7/21/21	<span style="color:red">6</span> Added Removal of Existing Delineators
7/14/21	<span style="color:red">4</span> Added Clear & Grub Limits
DATE	REVISION
STATE OF HAWAII DEPARTMENT OF TRANSPORTATION HIGHWAYS DIVISION	
<b>DEMOLITION AND EROSION CONTROL</b>	
<b>INTERSTATE ROUTE H-1 RESURFACING</b>	
Miller Pedestrian Overpass to Kapiolani Interchange	
Federal-Aid Project No. NH-HI-1(279)	
Scale: 1" = 40'	
Date: August 2021	
SHEET No. EC4 OF 23 SHEETS

<b>DEMOLITION AND EROSION CONTROL</b>	
INTERSTATE ROUTE H-1 RESURFACING	
Miller Pedestrian Overpass to Kapiolani Interchange	
Federal-Aid Project No. NH-HI-1(279)	
Scale: 1" = 40'	
Date: August 2021	
SIGNATURE	04/30/22
EXPIRATION DATE OF THE LICENSE	
SHEET No. EC7 OF 23 SHEETS

DEMOLITION AND EROSION CONTROL	
<u>INTERSTATE ROUTE H-1 RESURFACING</u>	
<u>Miller Pedestrian Overpass to Kapiolani Interchange</u>	
Federal-Aid Project No. NH-HI-1(279)	Date: August 2021
Scale: 1" = 40'	
SHEET No. EC8 OF 23 SHEETS

**SHEET NO. R6 OF 41 SHEETS**

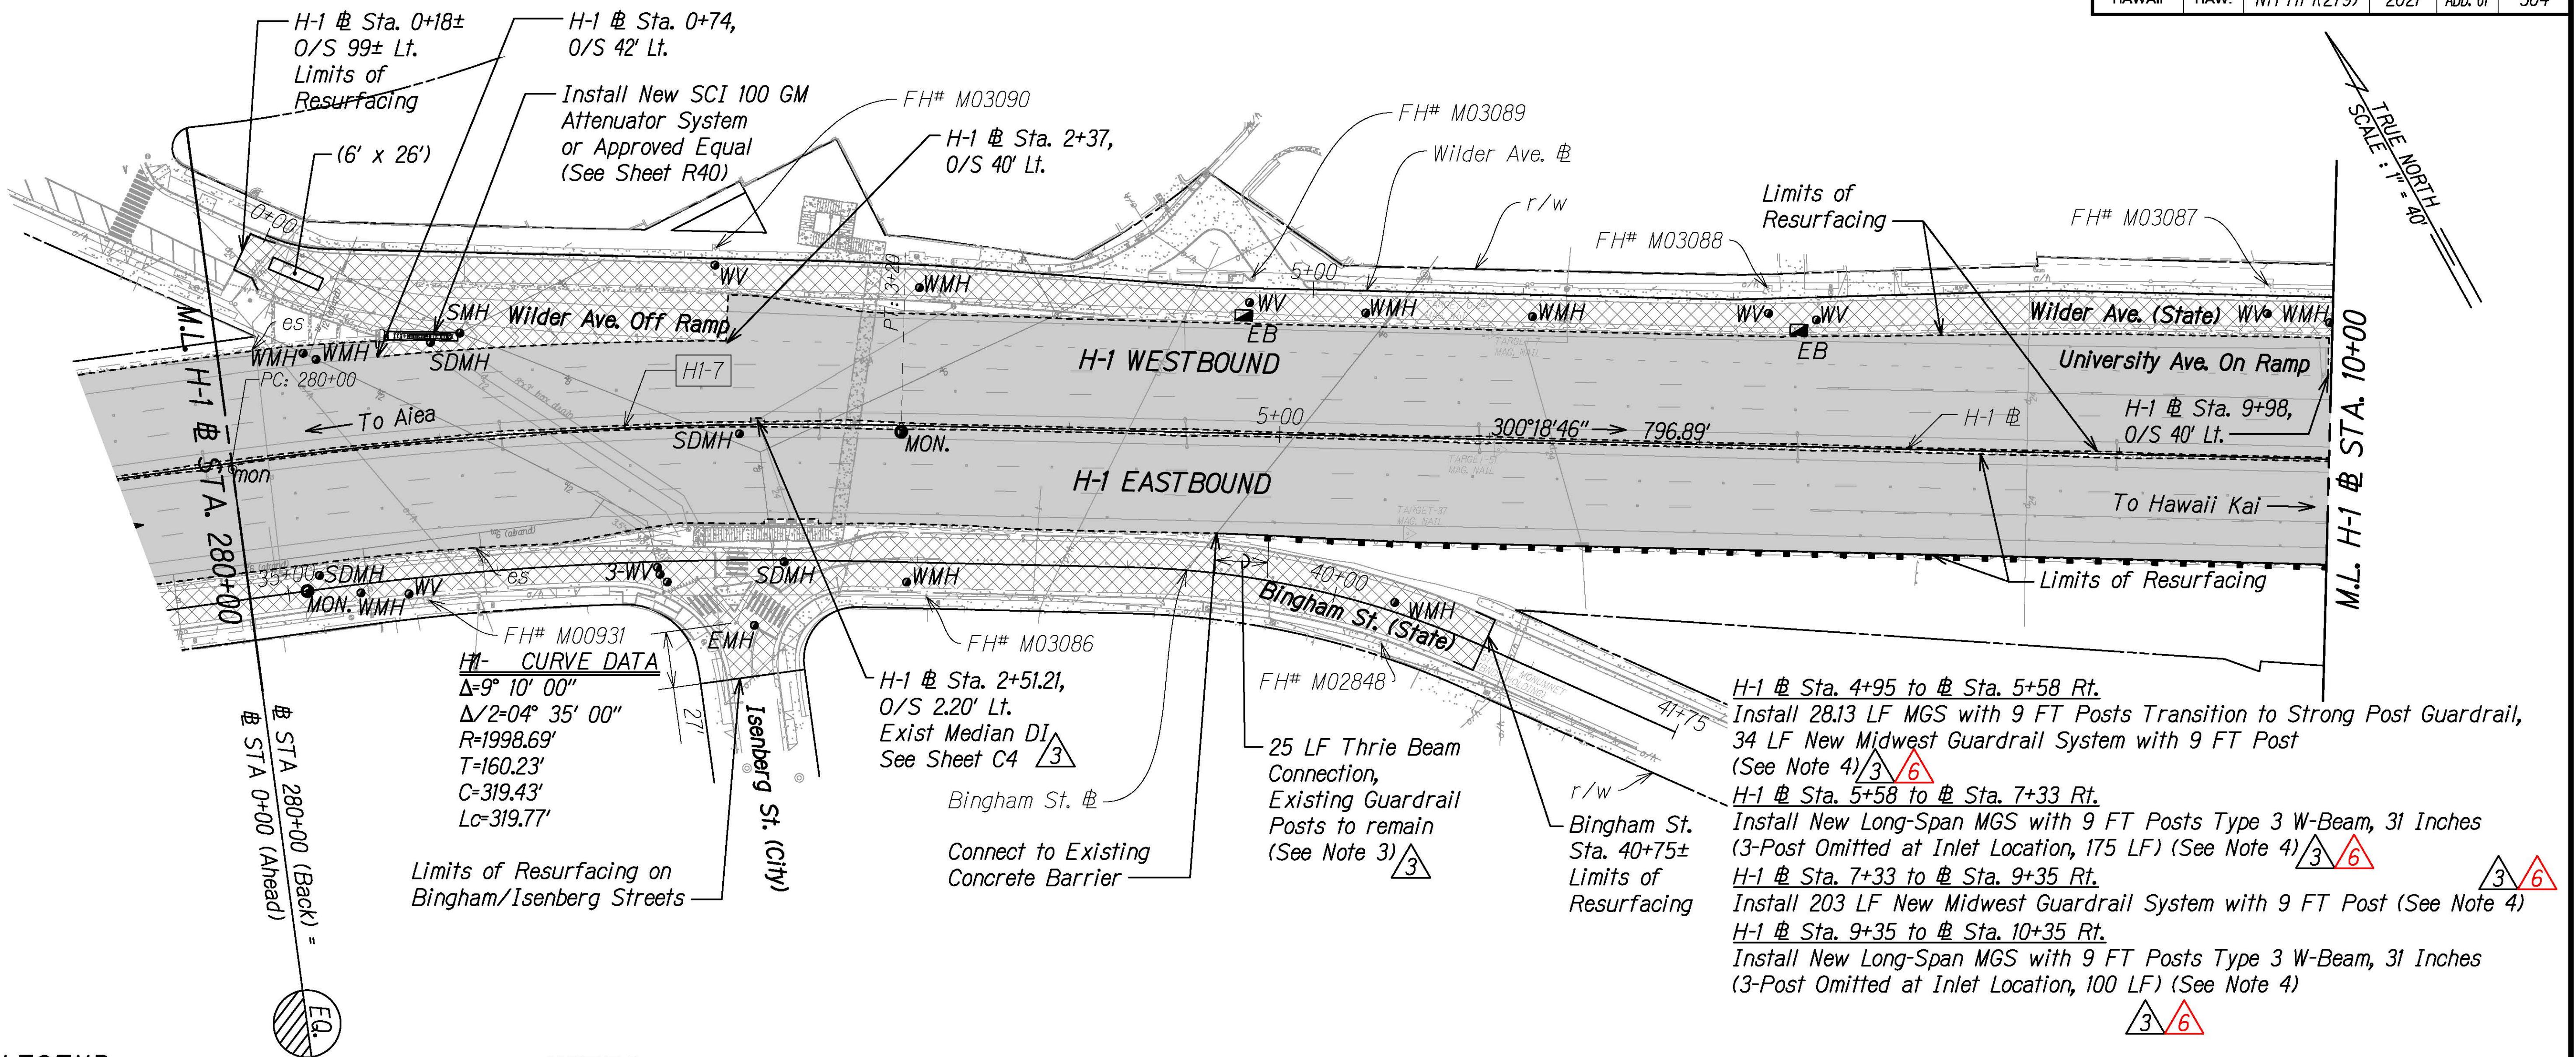
7/21/21	Revised Guardrails and Moved Attenuator
7/9/21	BWS Tracings, Revised Guardrails Resurfacing Limits and Pav't Section, Added Exist. Median DI label
DATE	REVISION

INTERSTATE ROUTE H-1 RESURFACING  
Miller Pedestrian Overpass to Kapiolani Interchange  
Federal-Aid Project No. NH-HI-1(279)  
Scale: 1" = 40'  
Date: August 2021  
SHEET No. R12 OF 41 SHEETS

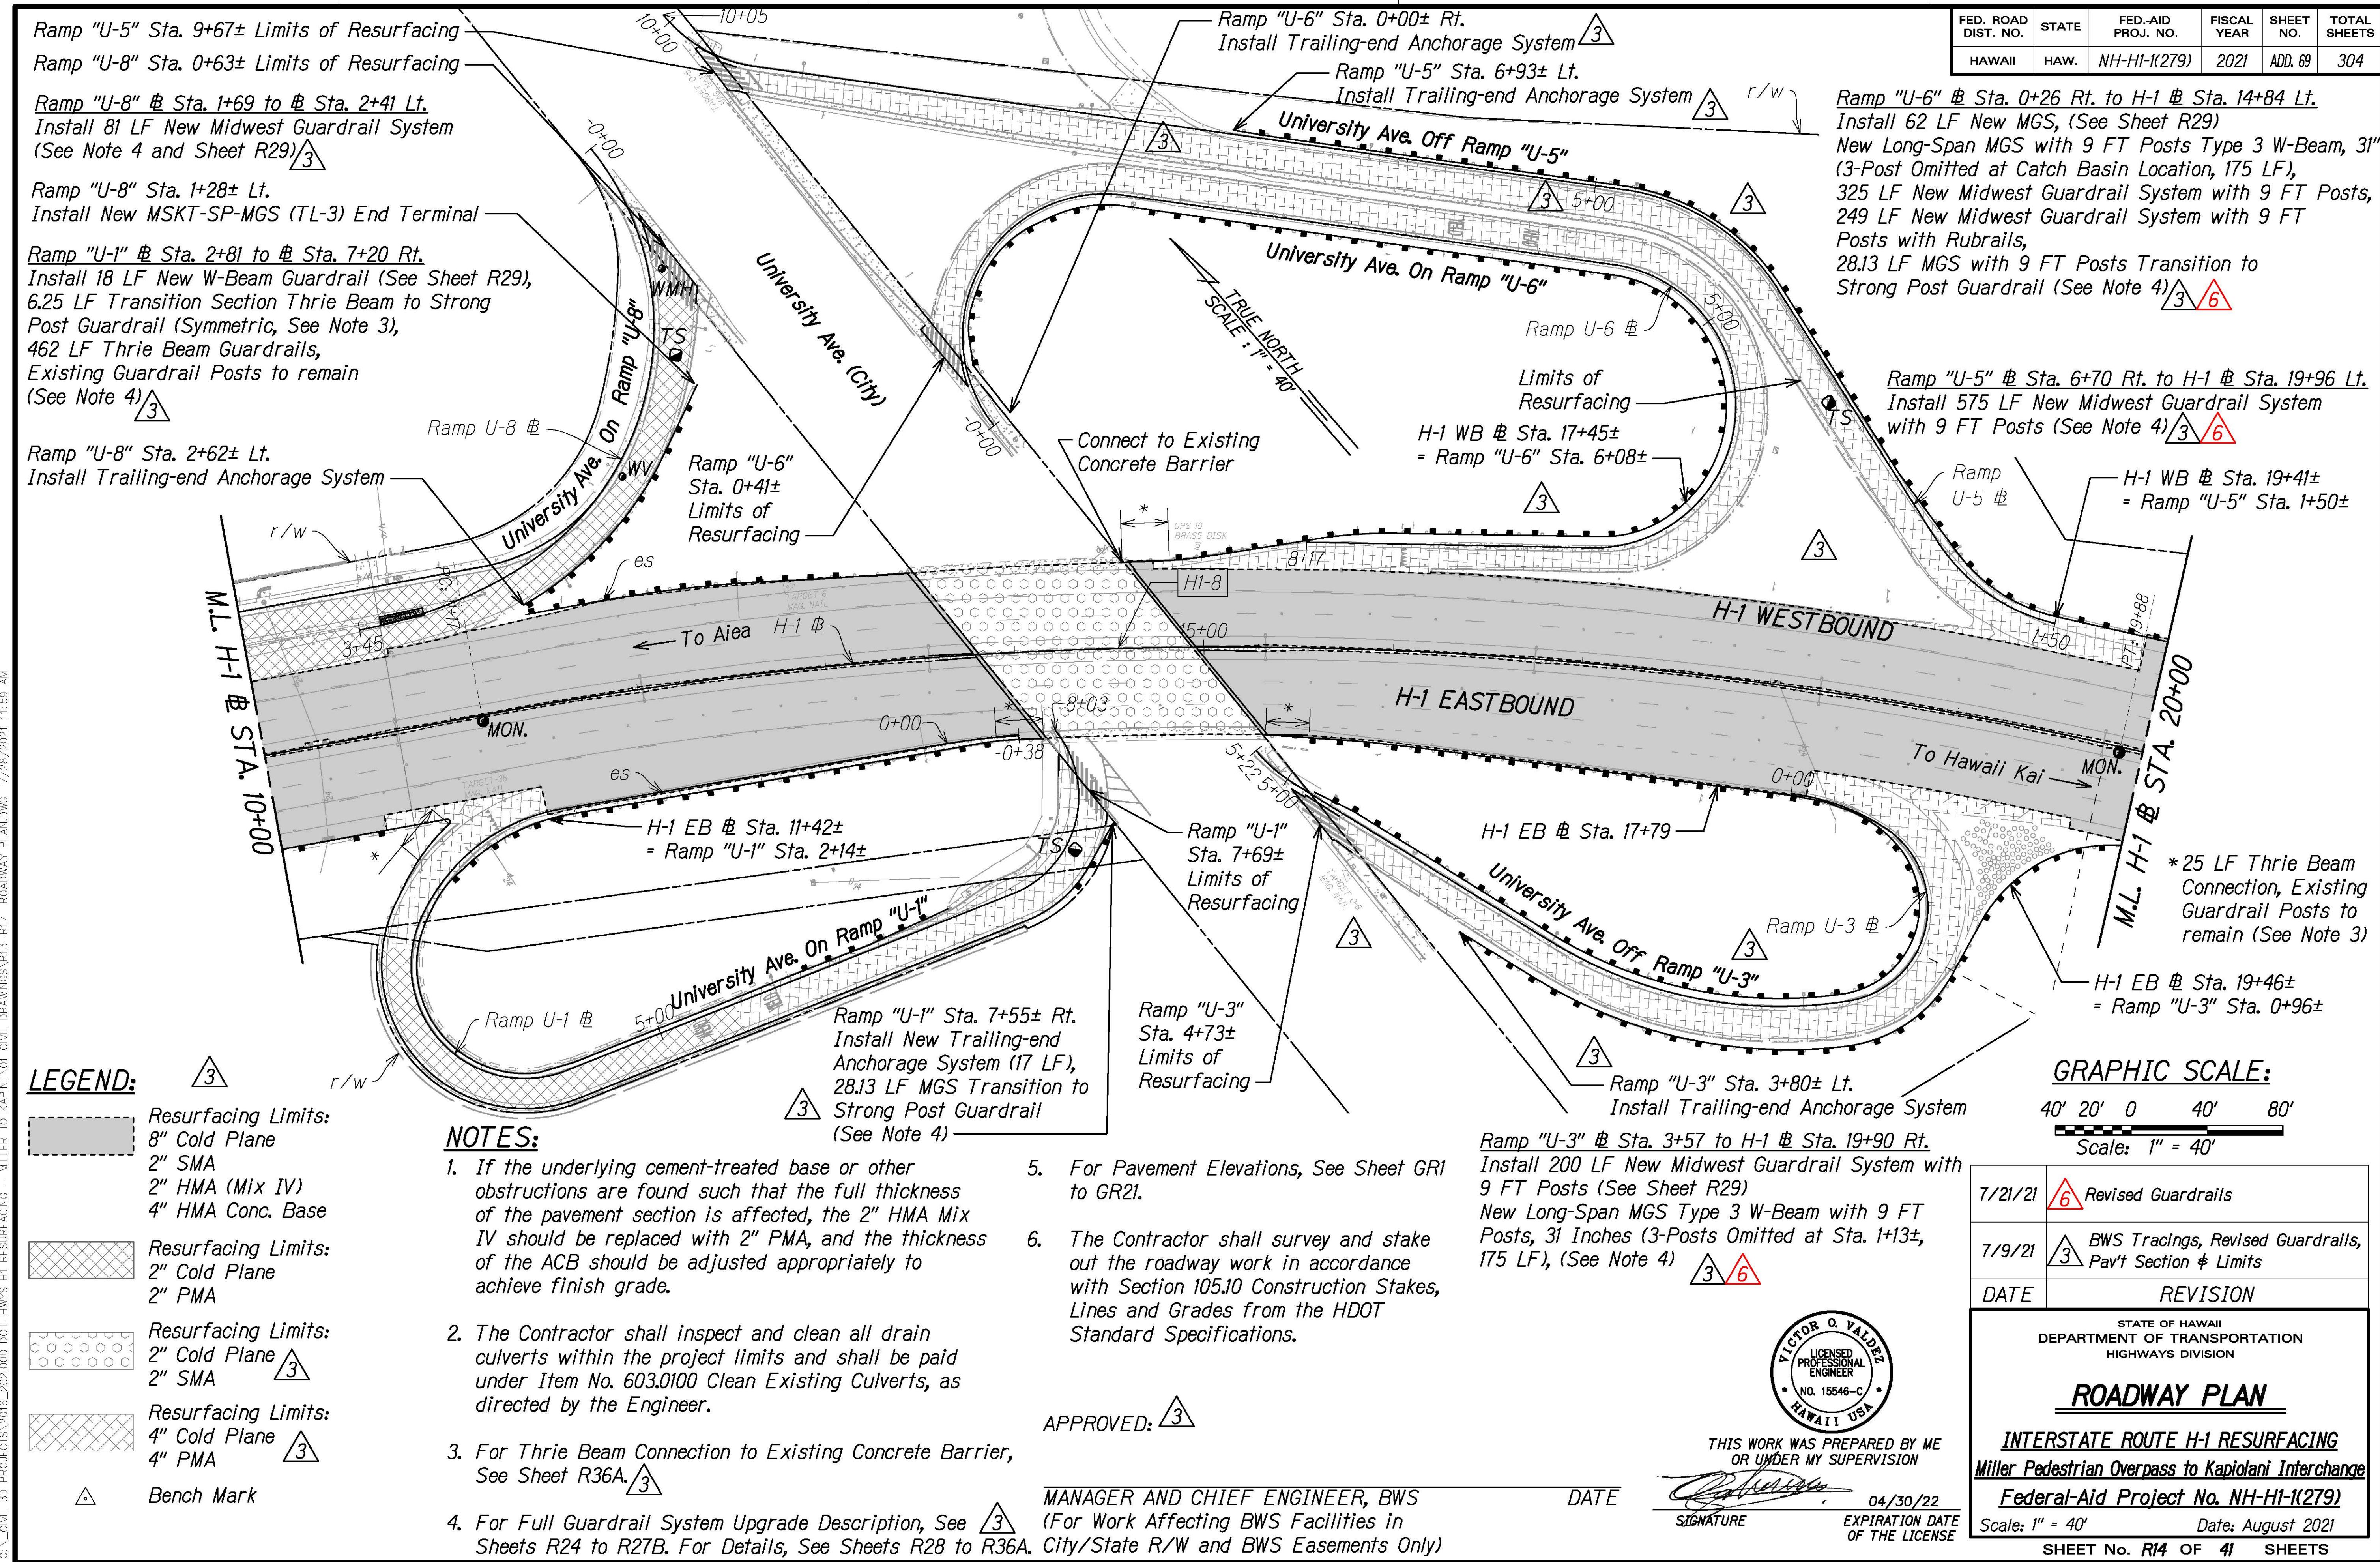
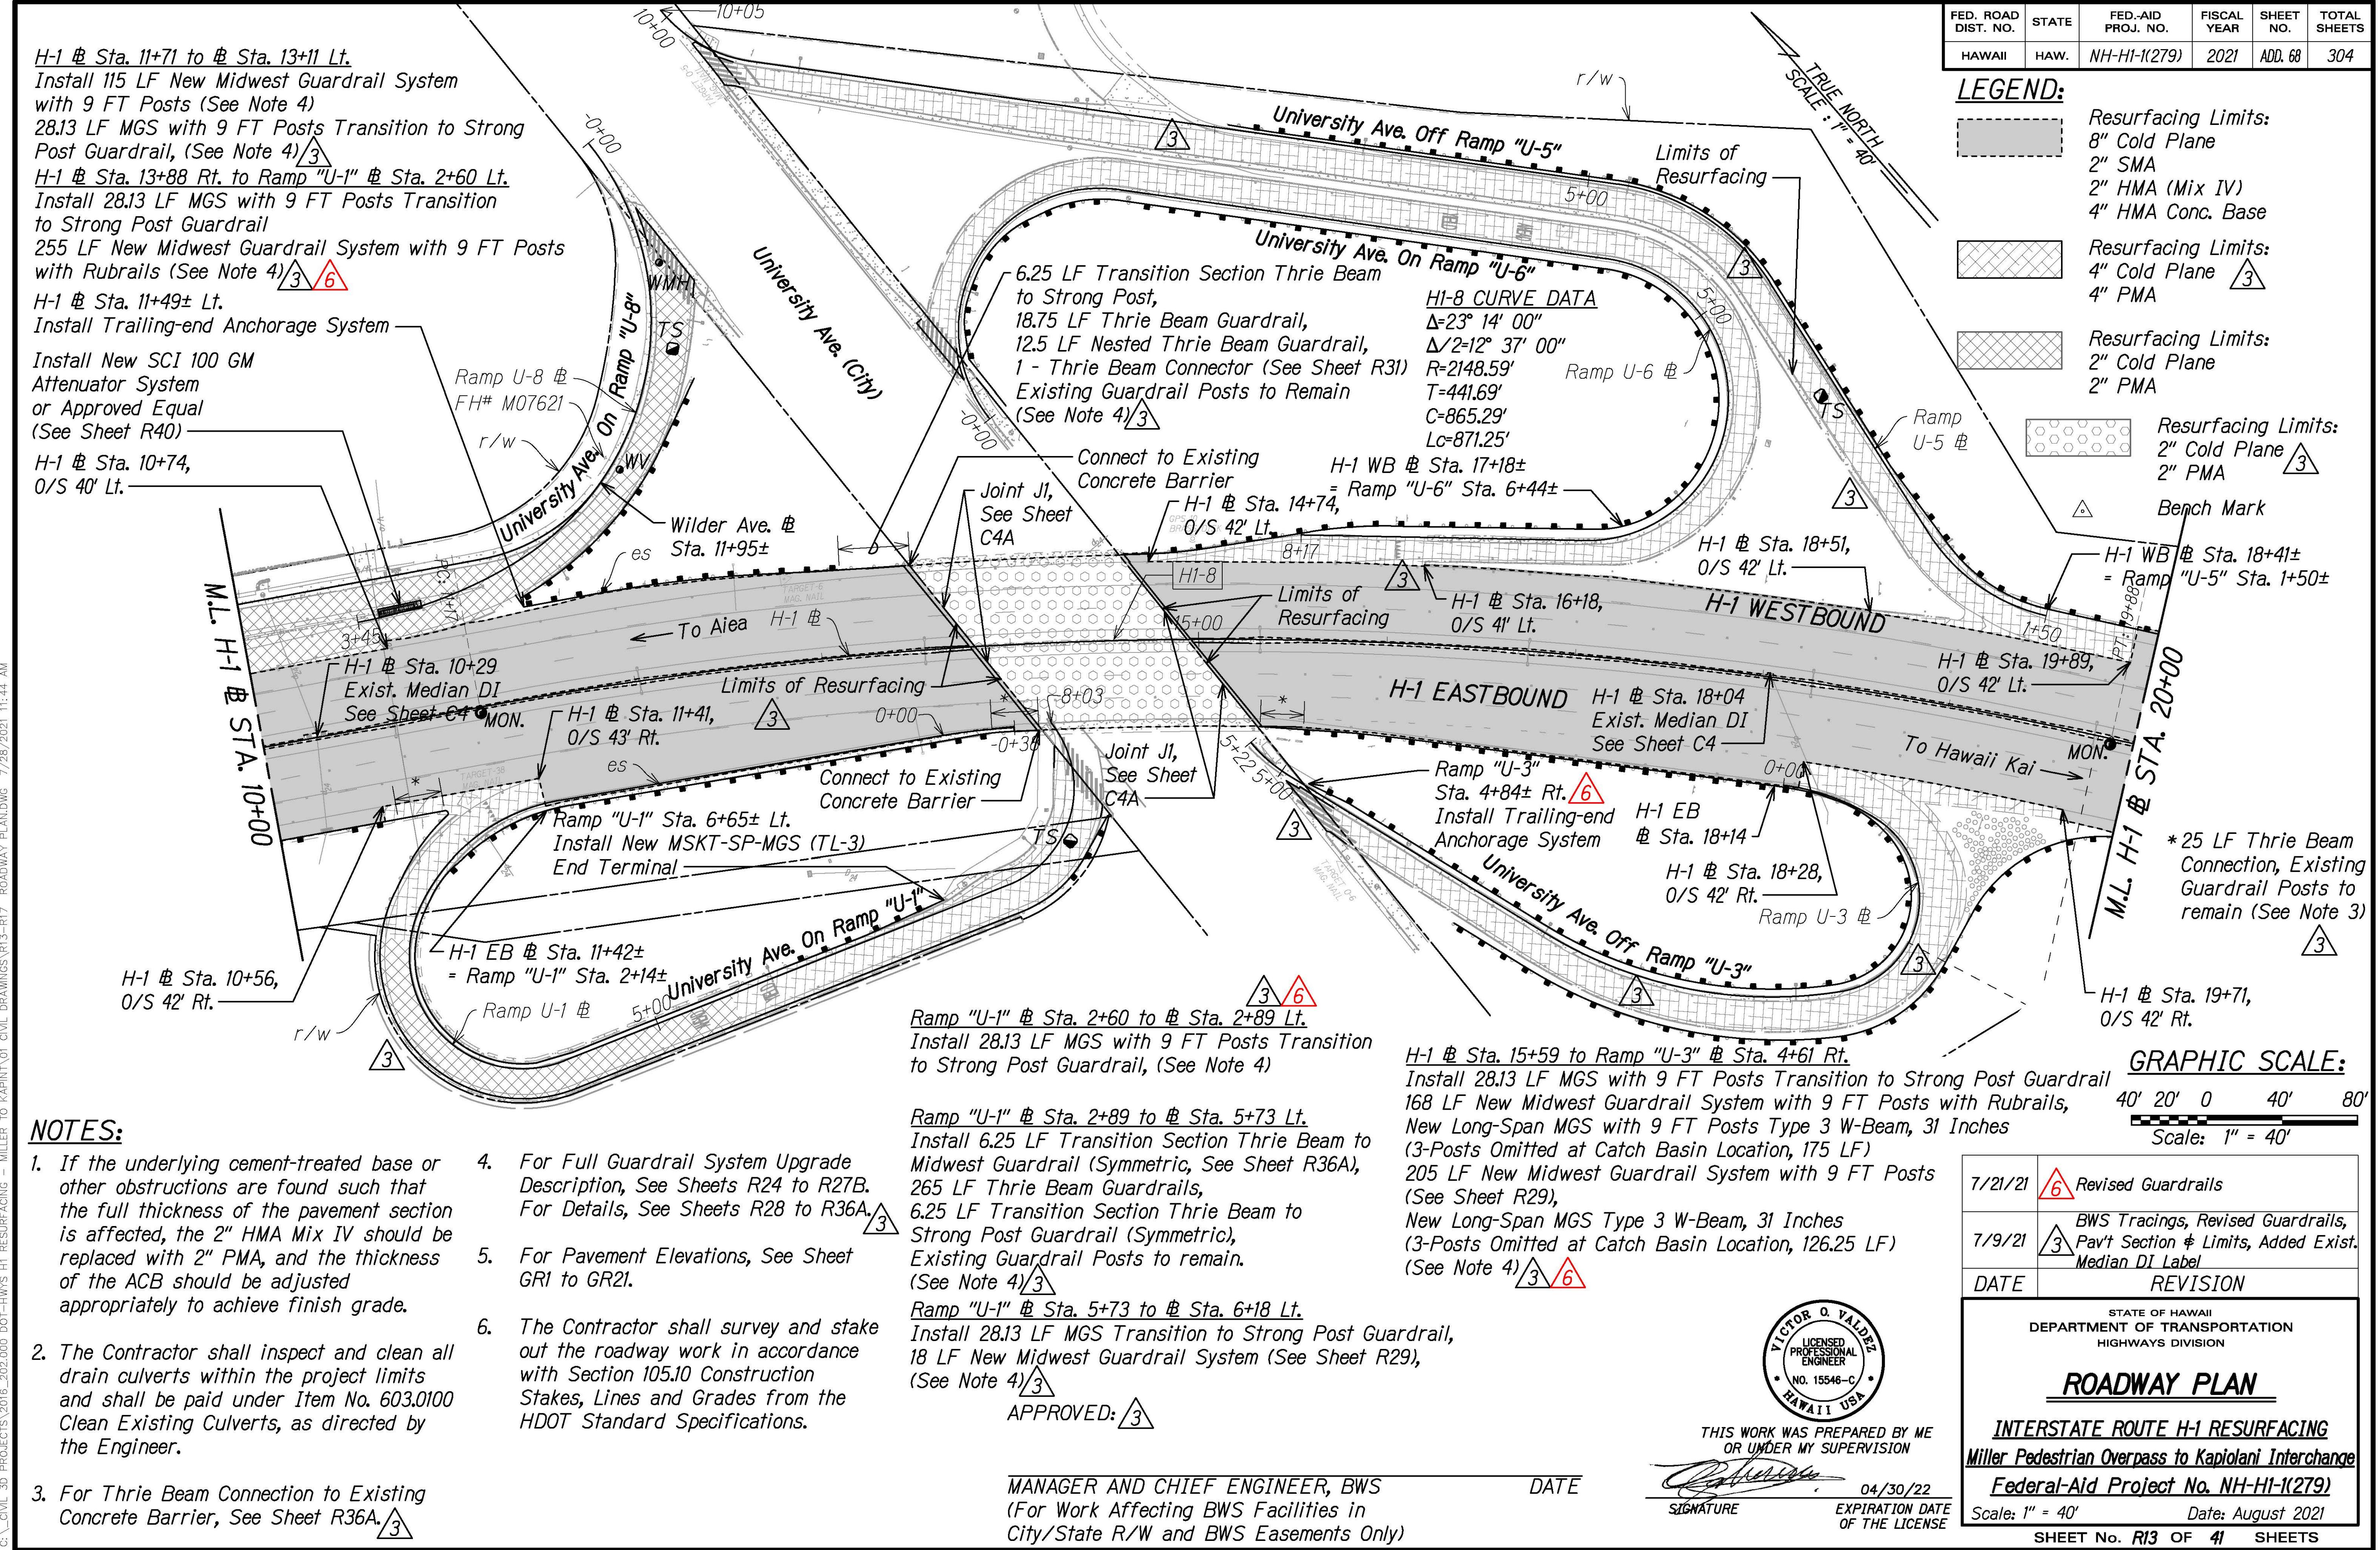
7/21/21	<span style="color:red">6</span> Revised Guardrails
7/9/21	<span style="color:red">3</span> BWS Tracings and Revised Guardrails Added Exist. Median DI label
DATE	REVISION

H-1 # Sta. 19+96 to Sta. 21+70 Lt.

Install New Long-Span MGS with 9 FT Posts

Type 3 W-Beam, 31 Inches

(3-Posts Omitted at Inlet Location, 175 LF), **6**

H-1 # Sta. 21+70 to Sta. 24+36 Lt.

Install 237 LF New Midwest Guardrail System

△ 6.25 LF Transition Section Thrie Beam  
to Strong Post,  
12.5 LF Thrie Beam Guardrail,  
12.5 LF Nested Thrie Beam Guardrail,  
1- Thrie Beam Connector (See Sheet R31)  
Existing Guardrail Posts to Remain  
(See Note 3)
